MEMORANDUM

City of Saugatuck Planning Commission

Memo Date:	September 12, 2025	Meeting Date:	September 18, 2025
Request:	Site Plan Review	Applicant:	Teresa Hendricks
Address:	142 Butler Street	Project Name:	Lucia's Imports
Parcel:	03-57-300-176-00	Plan Date:	July 28, 2025
Lot Size:	1,980 square feet	Zoning District:	City Center C-1
Complete:	Conditionally	Recommendation:	Deny or Postpone
City Staff:	Grayson Moore	Consultant:	David M. Jirousek, AICP

MAIN LEVEL SITE BUILDOUT PLAN
SCALE: 3/23" = 1'-0"

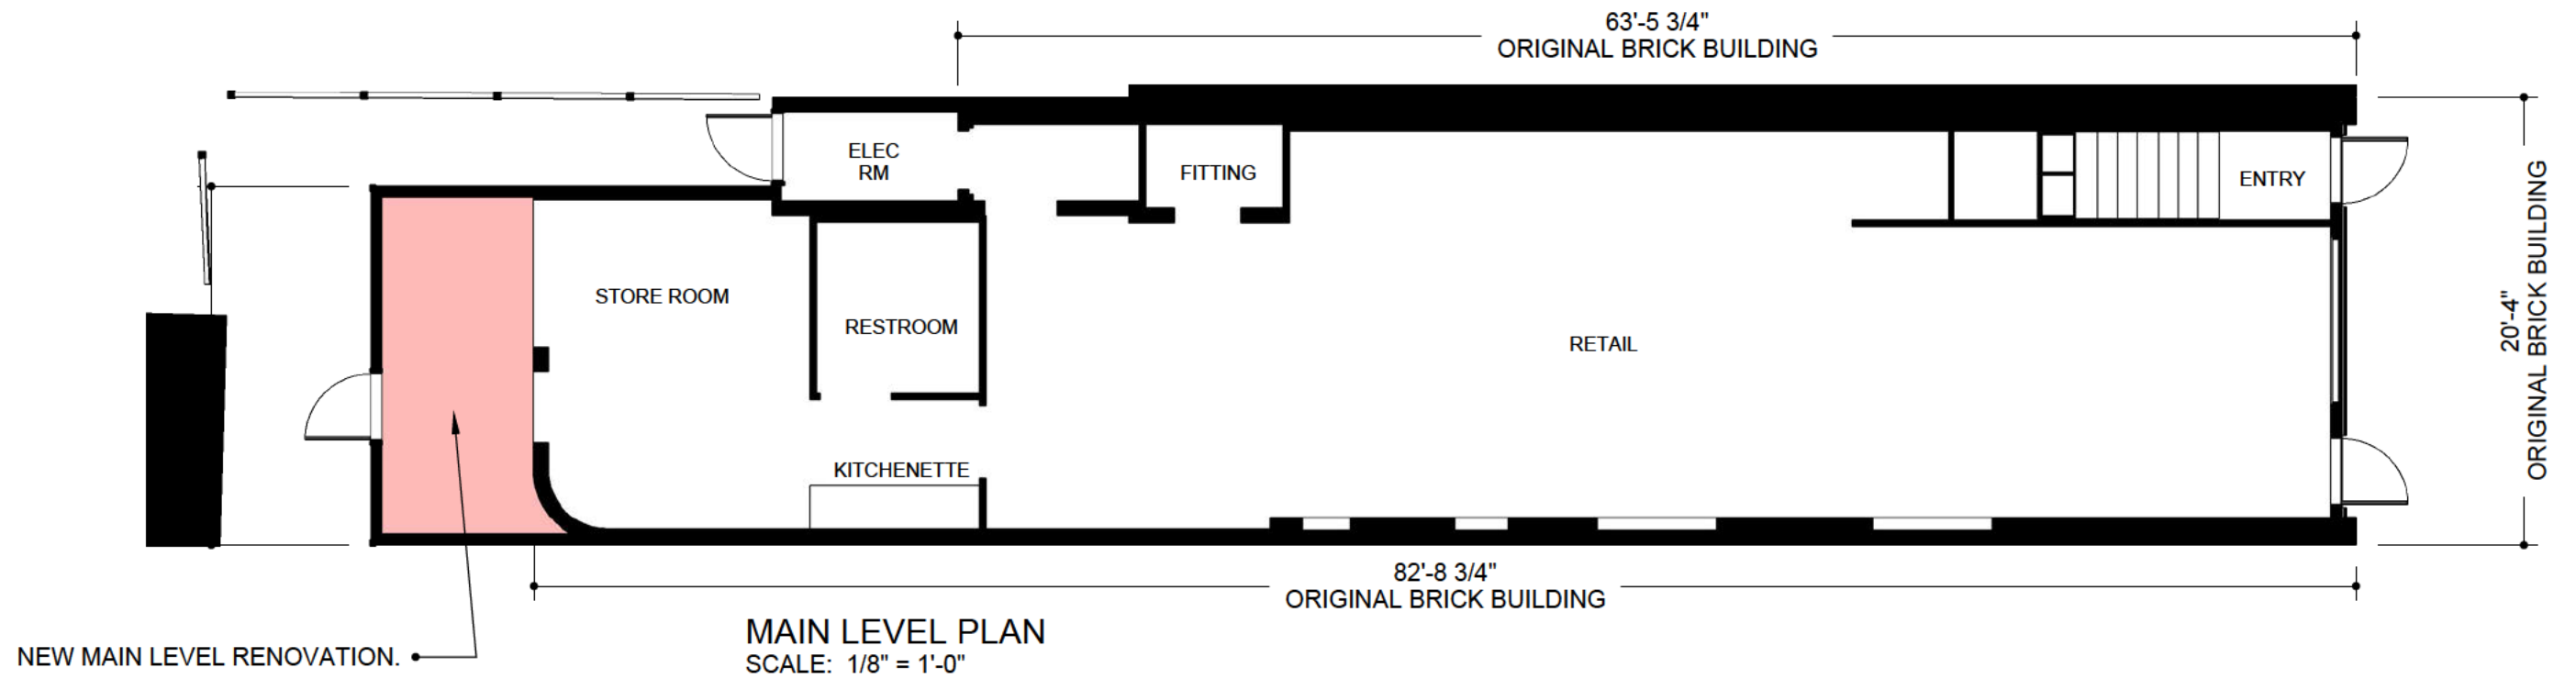
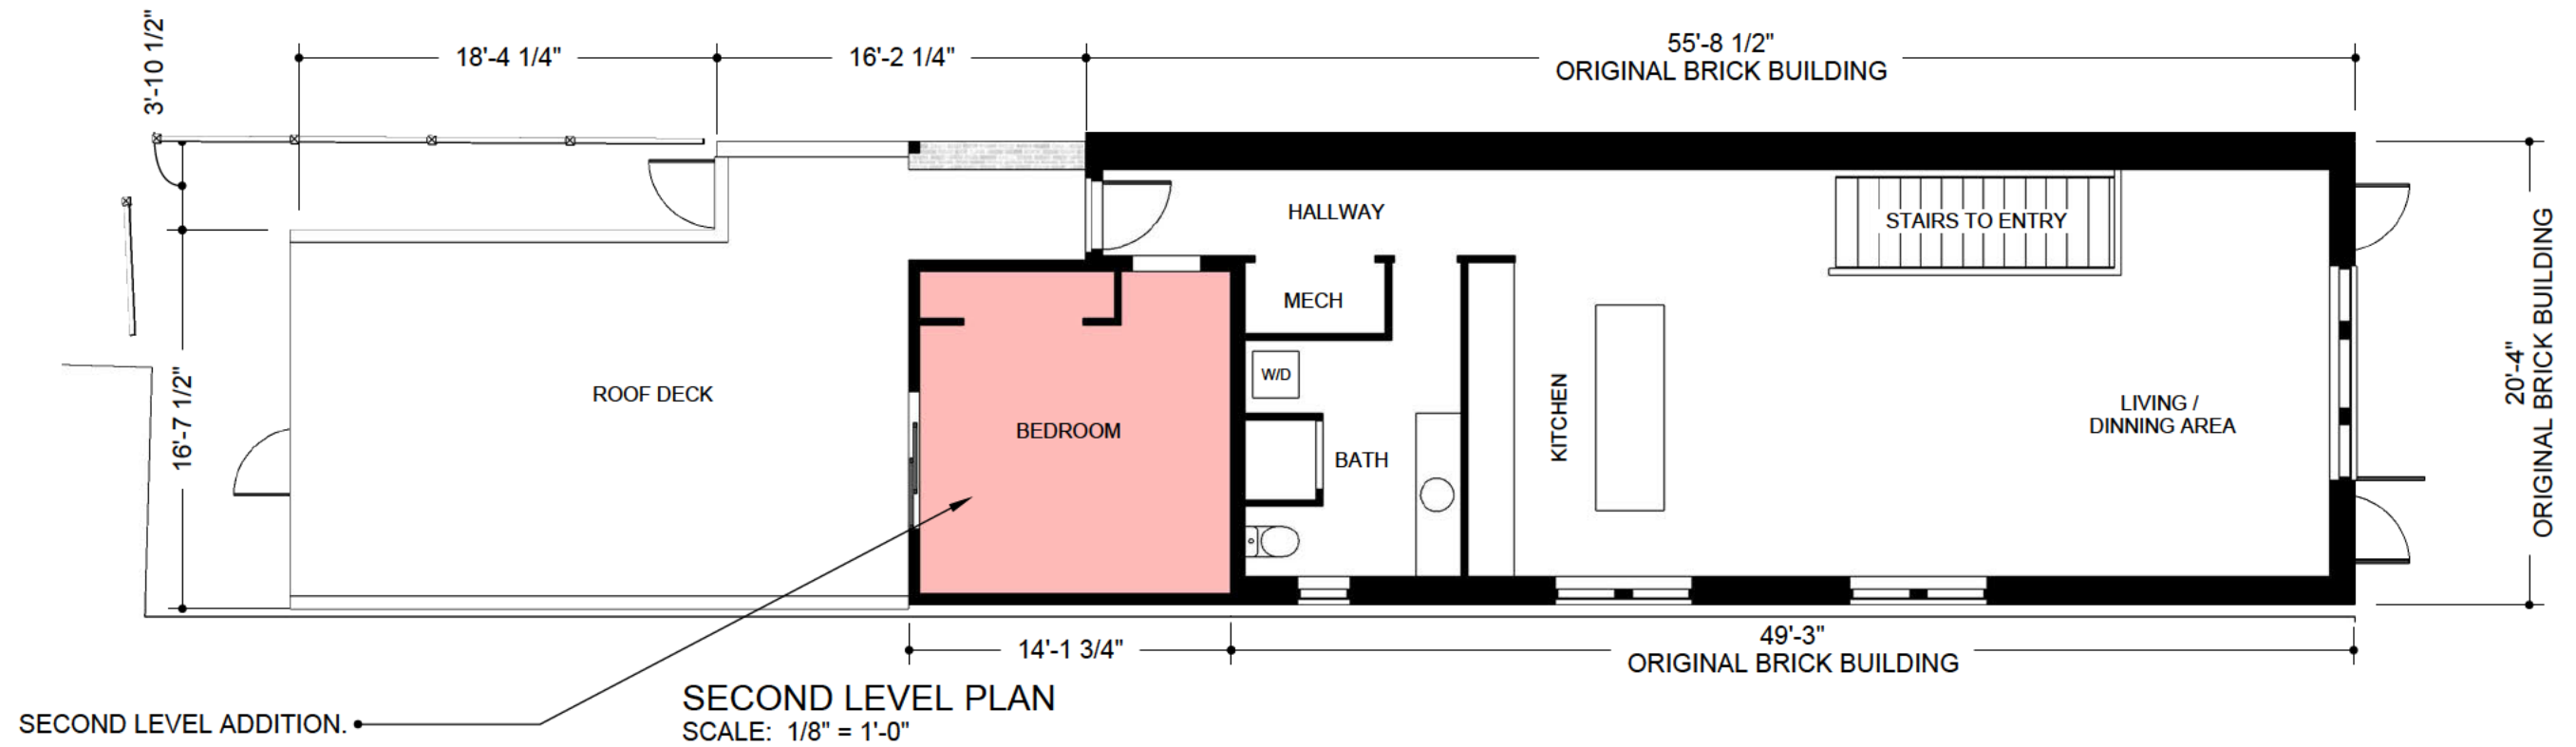
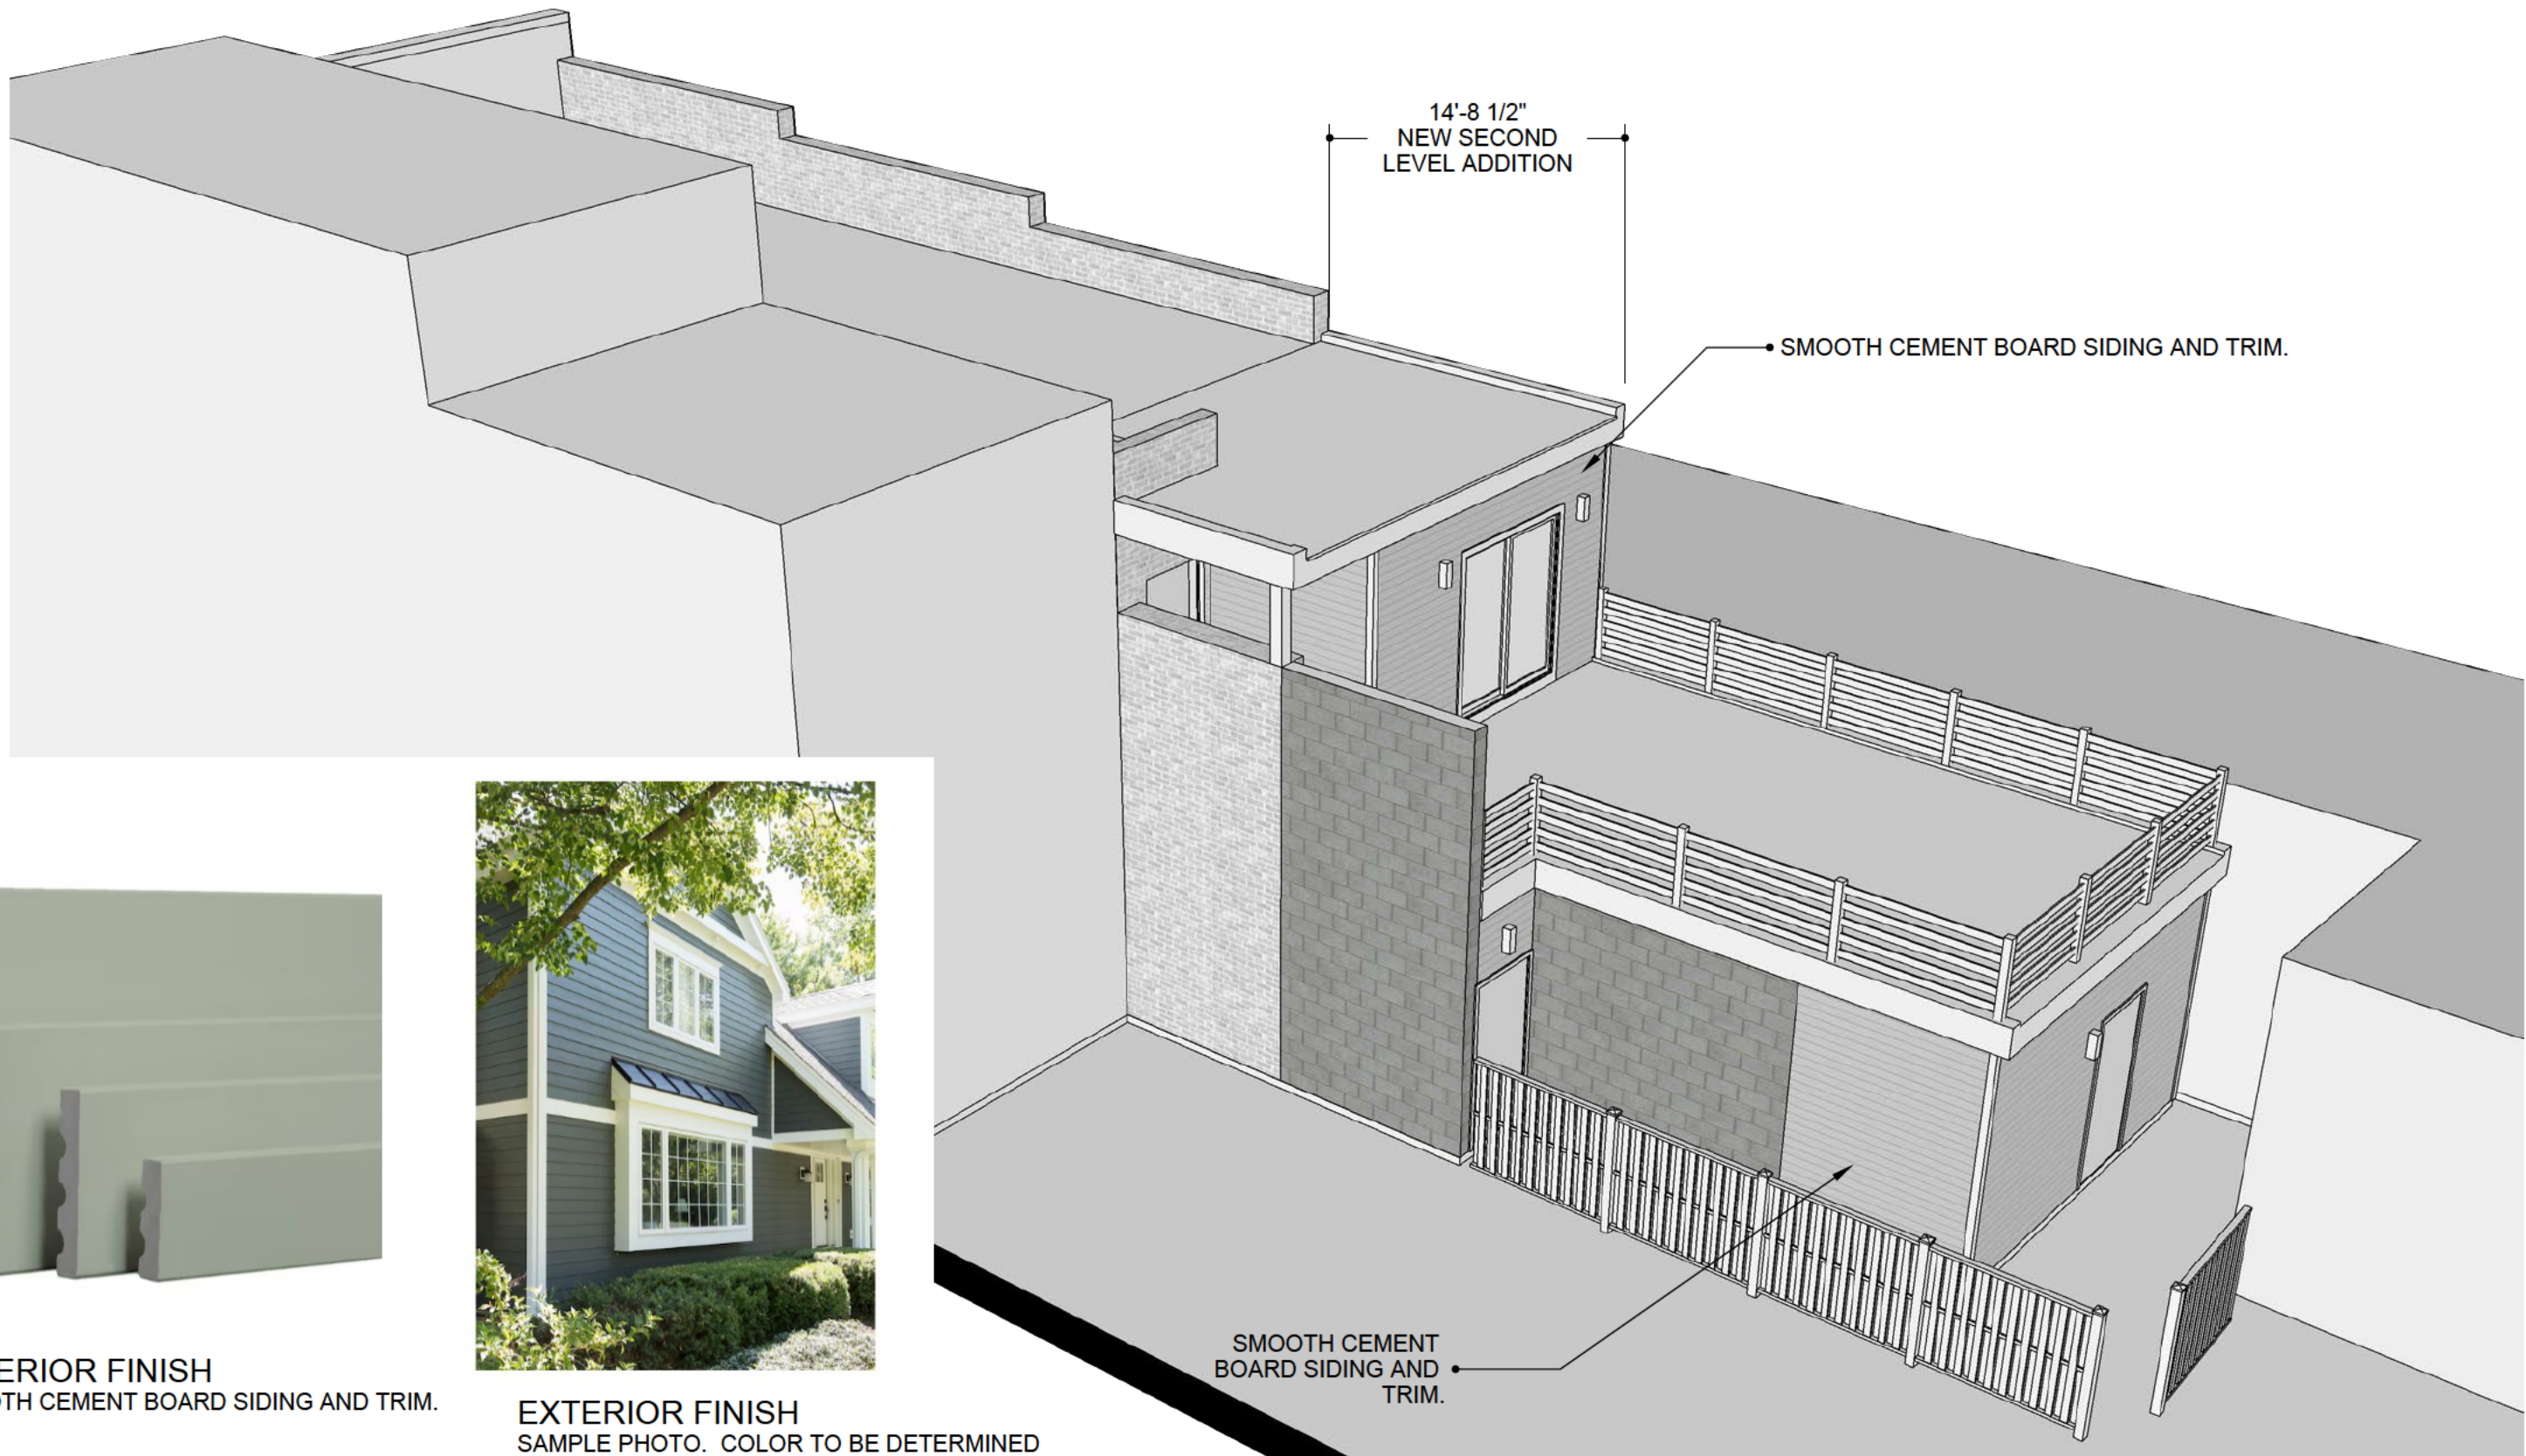
Nonconforming Structure Issue: The primary zoning issue with the proposal relates to the nonconforming nature of the existing building, which encroaches onto the lot to the south. The applicant is voluntarily removing a portion of the nonconforming first-floor structure and reconstructing across the lot line. Similarly, on the second floor, a portion of the structure will be removed and replaced with a new bedroom that also extends slightly into the area of encroachment.

The Zoning Ordinance provisions for nonconforming structures specify that a lawful nonconforming structure may not be enlarged, expanded, or altered in a way that increases its nonconformity. Alterations are permitted only if they comply fully with the ordinance at every structural level. Notably, the ordinance also provides that when nonconforming elements are eliminated or reduced, those characteristics cannot later be re-established or increased (except for certain repairs and replacement after disaster, etc.). The applicant's proposal reduces certain nonconforming elements by removing portions of the structure, but also reconstructs in a manner that perpetuates the existing nonconforming encroachment.

To address the encroachment, the project may require a slight "jog" in both the first- and second-floor additions, a variance request, or another compliant solution.
